City of Kirkland

NEW MIXED-USE DEVELOPMENT **SLATER**

Design Review Board Response

January 26th, 2021

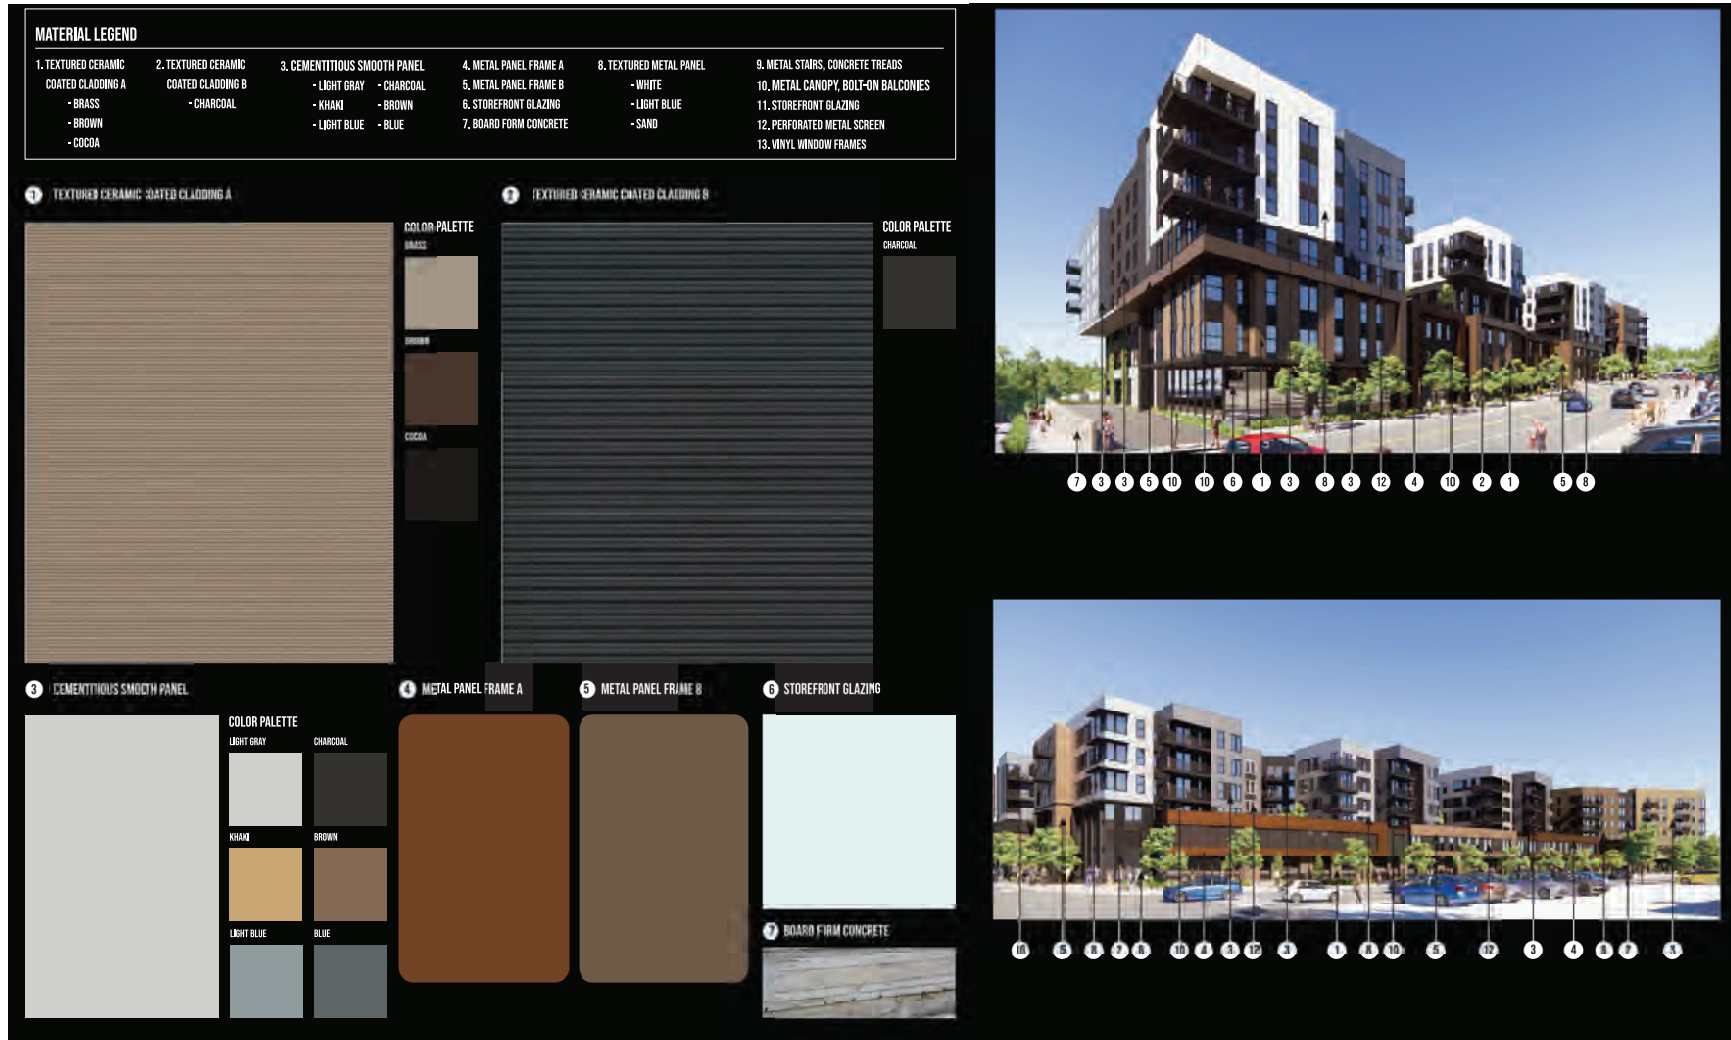
Request for clarification regarding location of balcony encroachments relative to the building or ground below. Concerned with balcony water runoff falling within the setback and right of way in particular from 120th St. facing balconies

Balcony encroachments along 120th Street repositioned to eliminate the encroachment over the setback and right of way. The balcony projections along Slater fall within the height setback and do not project into the yard or right of way.

VIEW ALONG 120TH STREET

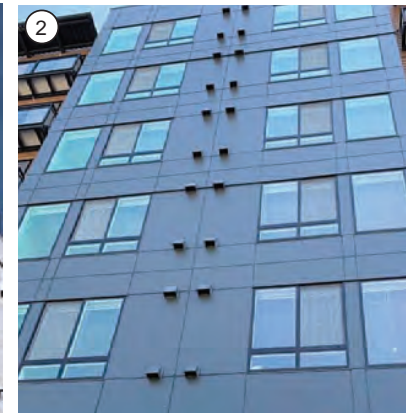
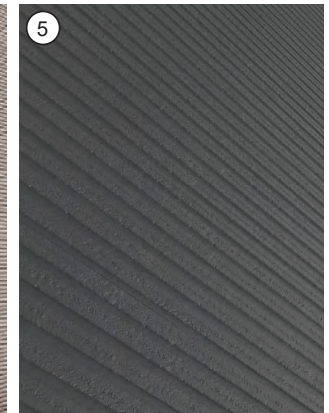
Request for more information related to proposed building materials and their application on the building. Design Team to provide actual samples via a material board and video of materials and/or actual installed examples.

Renderings have been enhanced to reflect finer grain of proposed materials by including a closer representation of their actual size and layout in the close up images provided. Renderings are also accompanied by photos of actual product applications.

City of Kirkland - Slater Mixed-Use Project | January 26, 2021 | content: BUILDING A REVISIONS

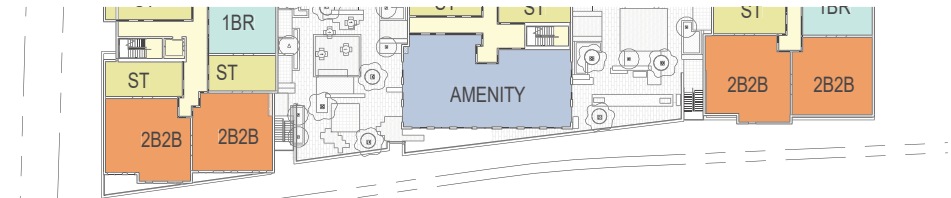
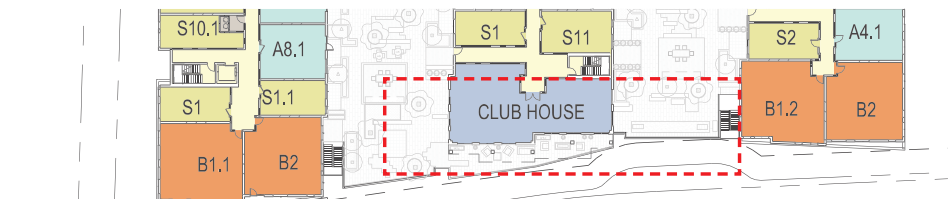
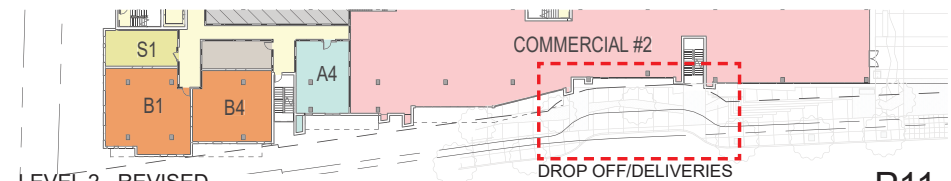
- * In general building façades appear flat
- * Additional articulation requested at rear building elevations.
- * Building parapet lines are too repetitive.
- * Building corners are too hard.
- * Slater facing elevation, long linear roof line has no variation.

Along NE 120th St. Design Team is confident “E” shaped building configuration resulting in staggered facade planes will not make the elevation appear flat. In addition the inclusion of a drop off/deliveries area along that frontage has further enhanced the articulation of the overall facade. Design Team does not believe further articulation of parapet lines is necessary.

City of Kirkland - Slater Mixed-Use Project | January 26, 2021 | content: BUILDING A NORTH ELEVATION REVISIONS

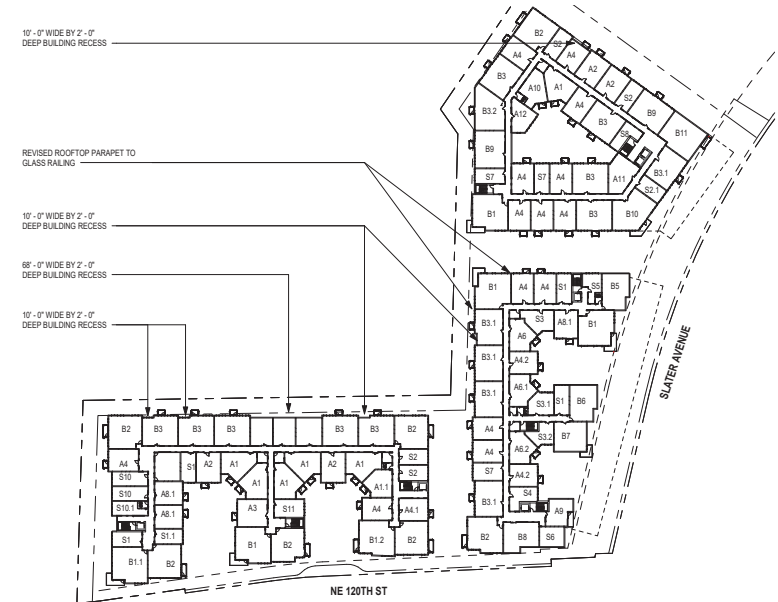
- * In general building façades appear flat
- * Additional articulation requested at rear building elevations.
- * Building parapet lines are too repetitive.
- * Building corners are too hard.
- * Slater facing elevation, long linear roof line has no variation.

At rear elevations additional articulation provided at residential areas by introducing recesses along facade as well as color variations. Added parapet variations at select locations and to highlight roof amenity area at Building B.

METAL SCREENING DETAIL

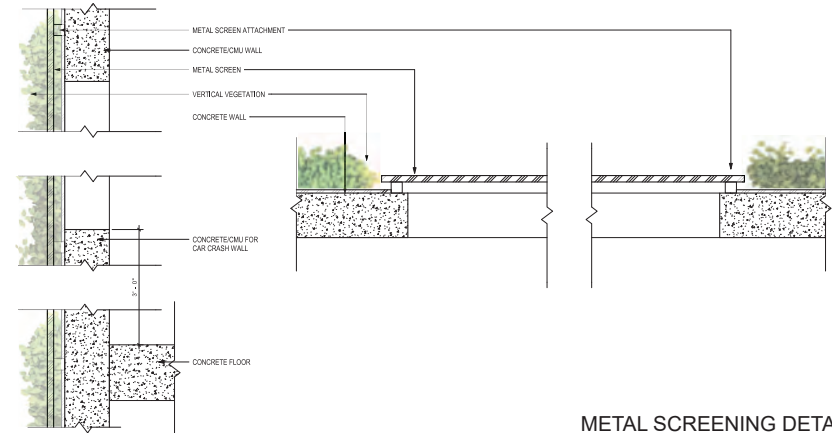
- * In general building façades appear flat
- * Additional articulation requested at rear building elevations.
- * Building parapet lines are too repetitive.
- * Building corners are too hard.
- * Slater facing elevation, long linear roof line has no variation.

At rear elevations additional articulation provided at parking areas by further articulating the proposed garage screen. Additionally, vertical screening elements added which will use similar material as garage screening.

TYPICAL SECTION ALONG SLATER

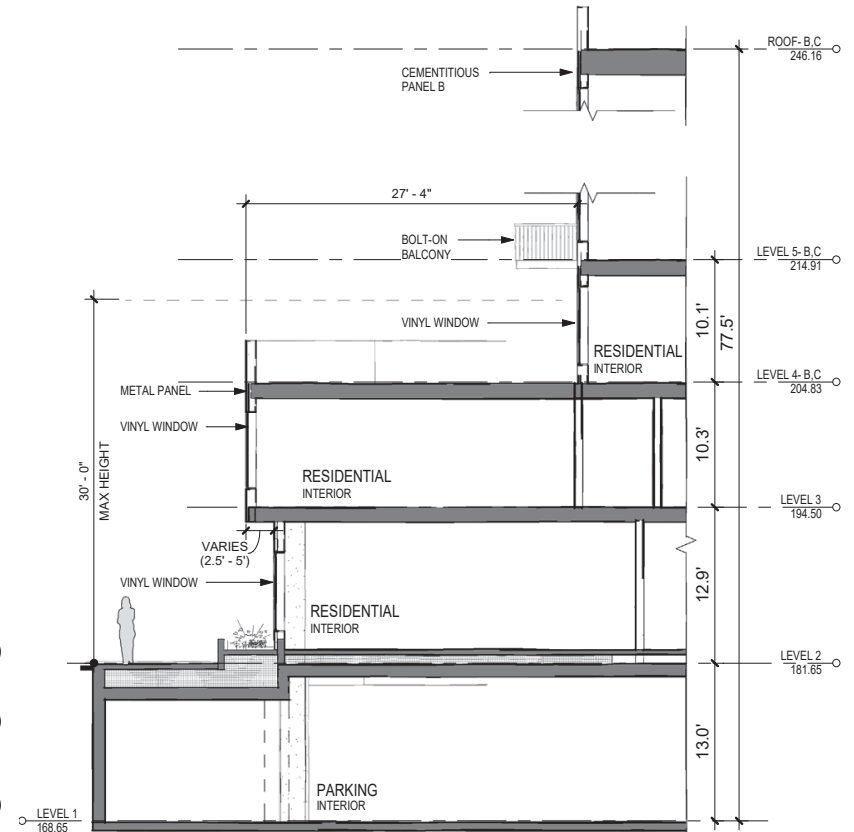
- * In general building façades appear flat
- * Additional articulation requested at rear building elevations.
- * Building parapet lines are too repetitive.
- * Building corners are too hard.
- * Slater facing elevation, long linear roof line has no variation.

Variation added along Slater Ave. via use of different shades of color for the proposed linear volumes. Materials scale and layout further represented by including photos of actual product applications as seen on P4 & P5. Additionally, the below wall sections details the horizontal breaks while moving up the building. Thus providing a comfortable pedestrian scale for those walking along the sidewalk.

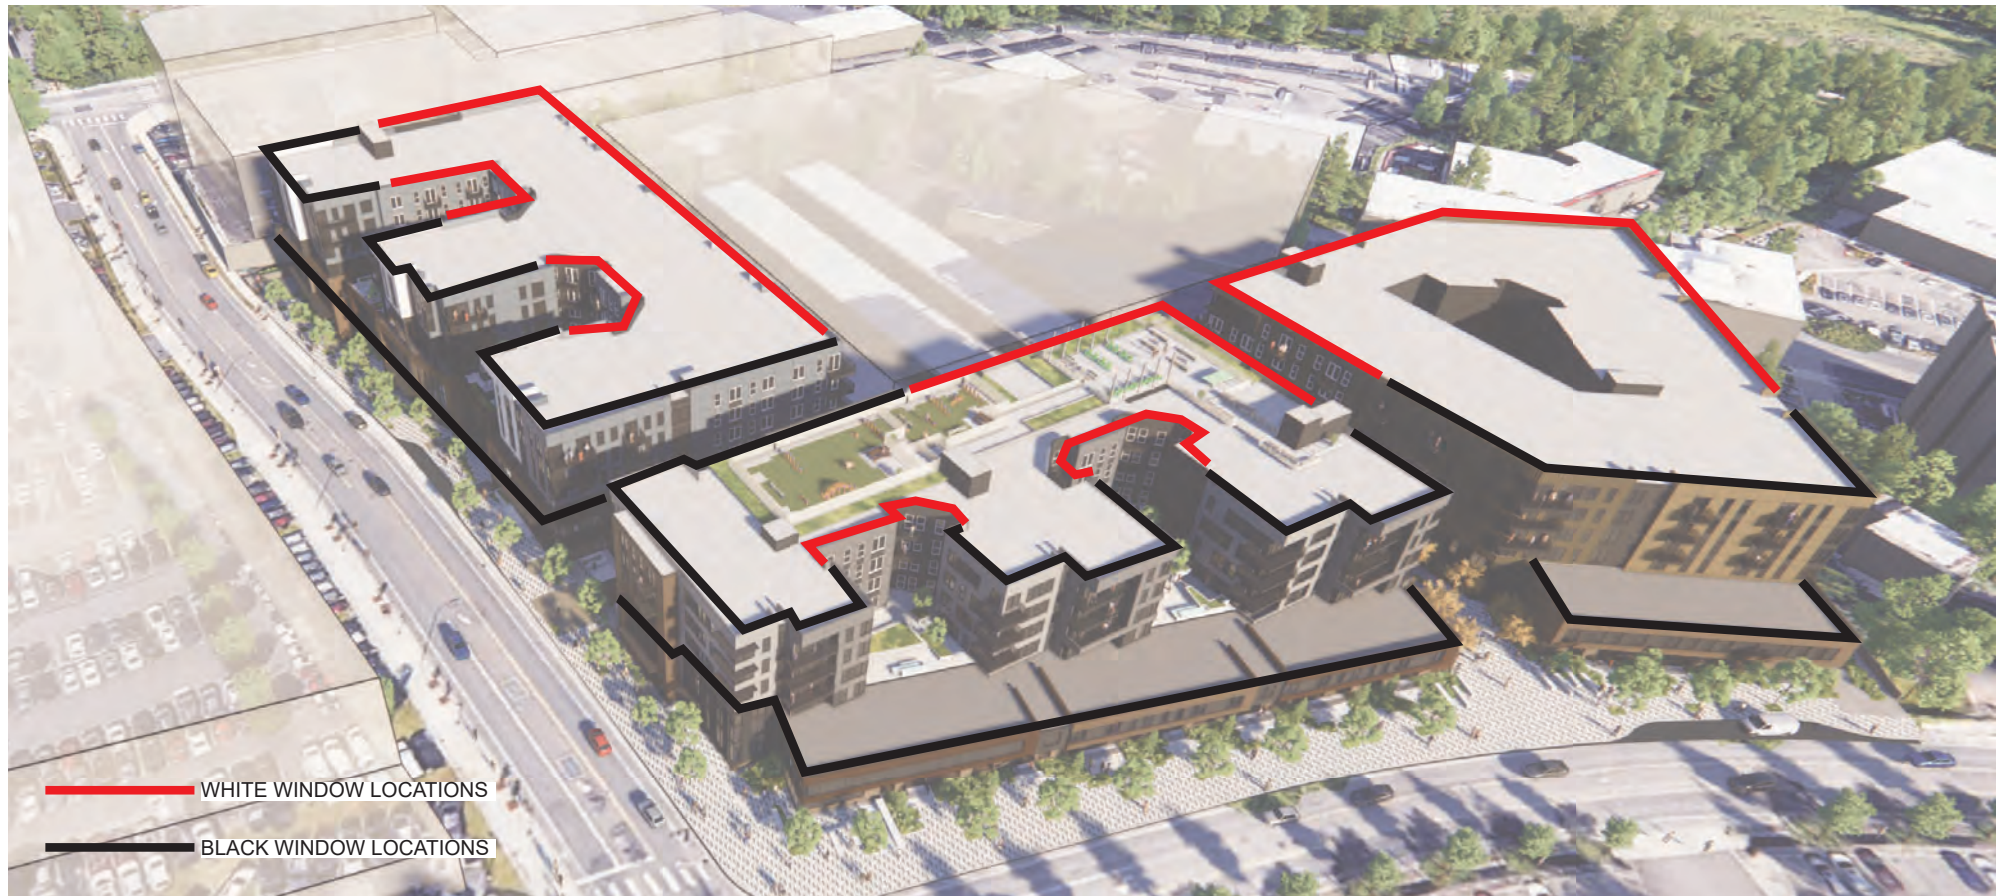
Encouraged Design Team to further study use of white vinyl windows and consider other alternatives.

Design Team proposes black vinyl windows at facades readily visible from public right of way and limit use of white vinyl windows to remaining areas.

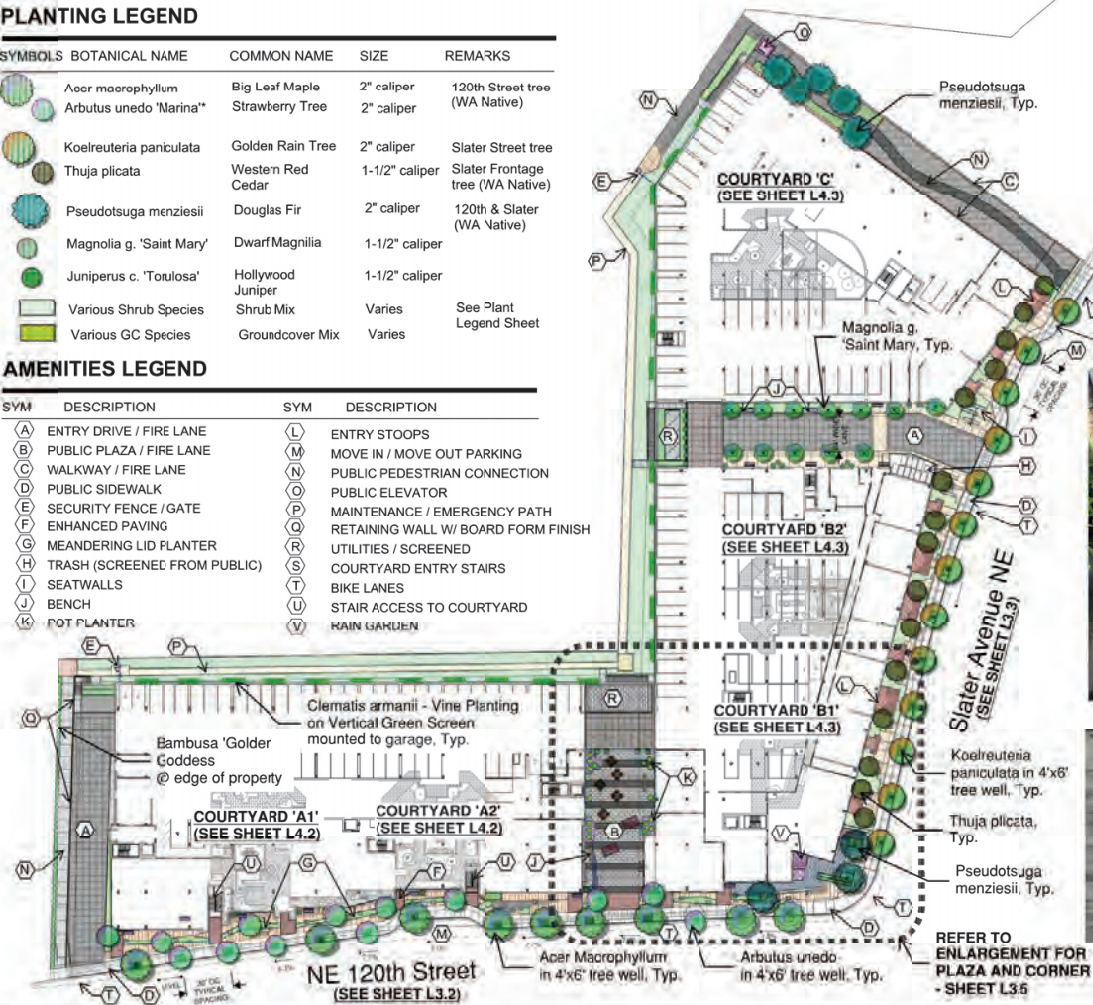
- Request for further clarification regarding the space behind the building
- Bollards at the end of our public plaza; possible risk to kids walking into the vehicular travel way
- Additional detailing of driveway spaces; what are the pedestrian features (designated walkway, seating, planting, etc.)

Landscape site plan notes gate locations which limit access to areas behind the building due to safety concerns. Ample lighting as shown on sheet P19 also provided in that area bollards are needed to remain to meet utility company requirements. Landscape site plan notes locations for seat walls, benches, entry stoops to enhance the pedestrian experience.

STREET ENLARGEMENT ALONG NE 120TH STREET)

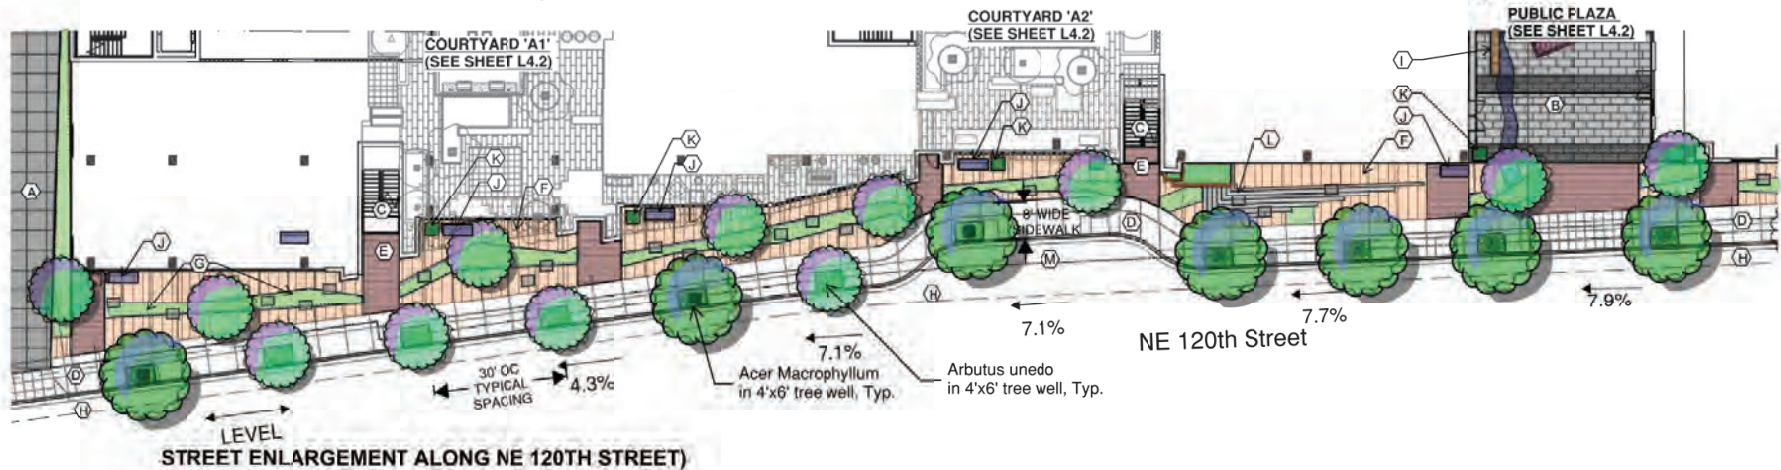
- Request for further clarification regarding the space behind the building
- Bollards at the end of our public plaza; possible risk to kids walking into the vehicular travel way
- Additional detailing of driveway spaces; what are the pedestrian features (designated walkway, seating, planting, etc.)

Landscape site plan notes gate locations which limit access to areas behind the building due to safety concerns. Ample lighting as shown on sheet P19 also provided in that area bollards are needed to remain to meet utility company requirements. Landscape site plan notes locations for seat walls, benches, entry stoops to enhance the pedestrian experience.

STREET VIEW ALONG SLATER AVENUE NE

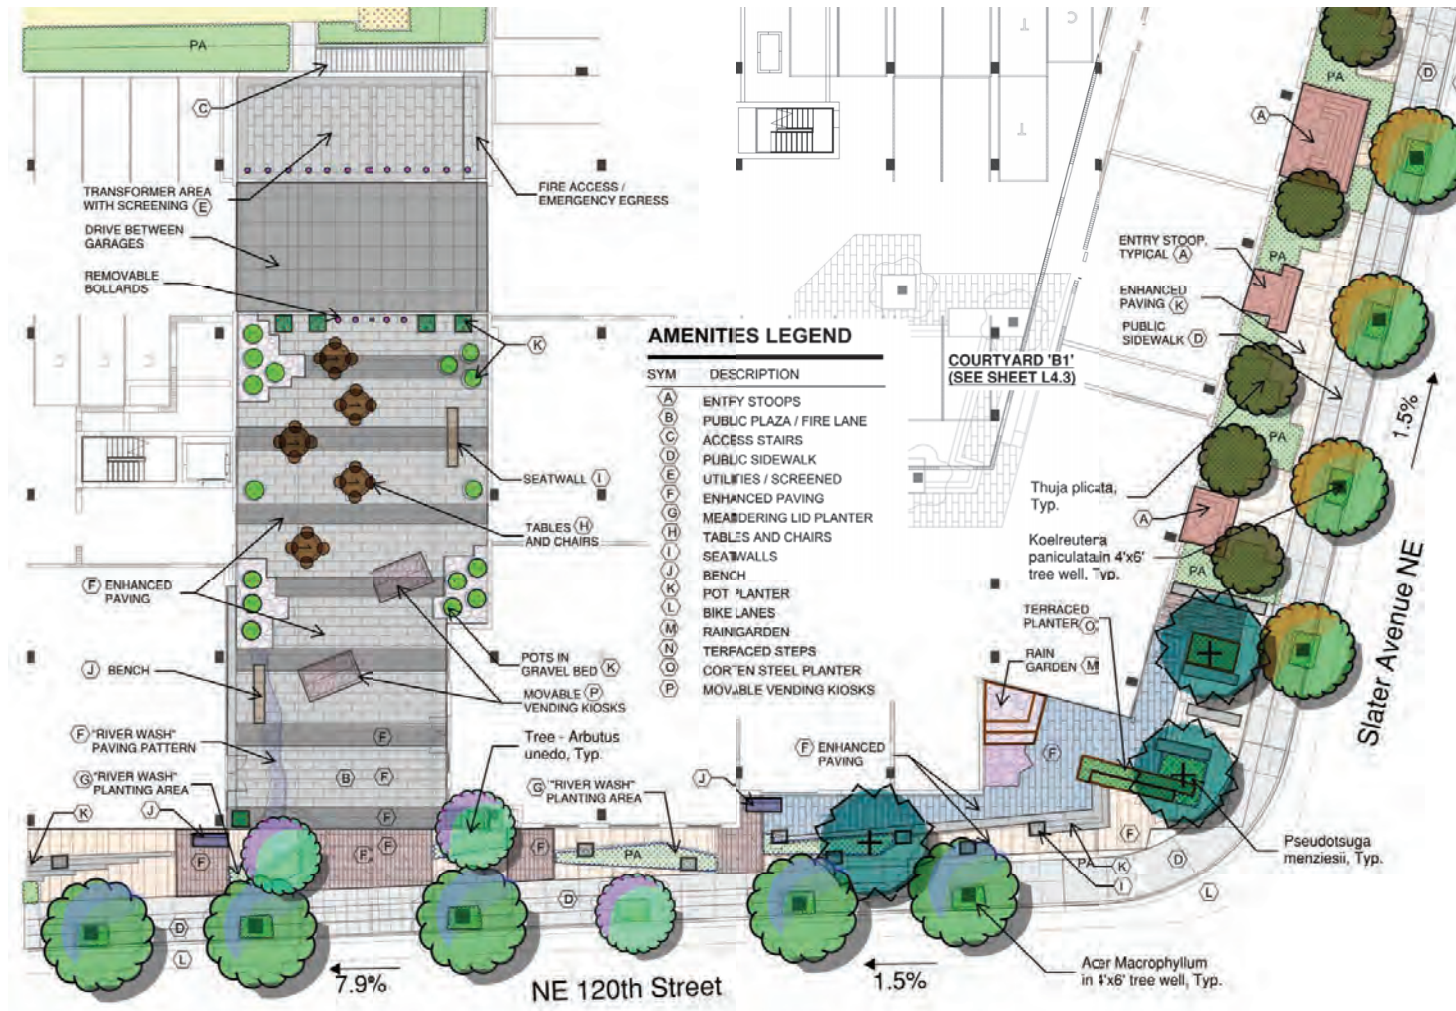
- Request for further clarification regarding the space behind the building
- Bollards at the end of our public plaza; possible risk to kids walking into the vehicular travel way
- Additional detailing of driveway spaces; what are the pedestrian features (designated walkway, seating, planting, etc.)

Landscape site plan notes gate locations which limit access to areas behind the building due to safety concerns. Ample lighting as shown on sheet P19 also provided in that area bollards are needed to remain to meet utility company requirements. Landscape site plan notes locations for seat walls, benches, entry stoops to enhance the pedestrian experience.
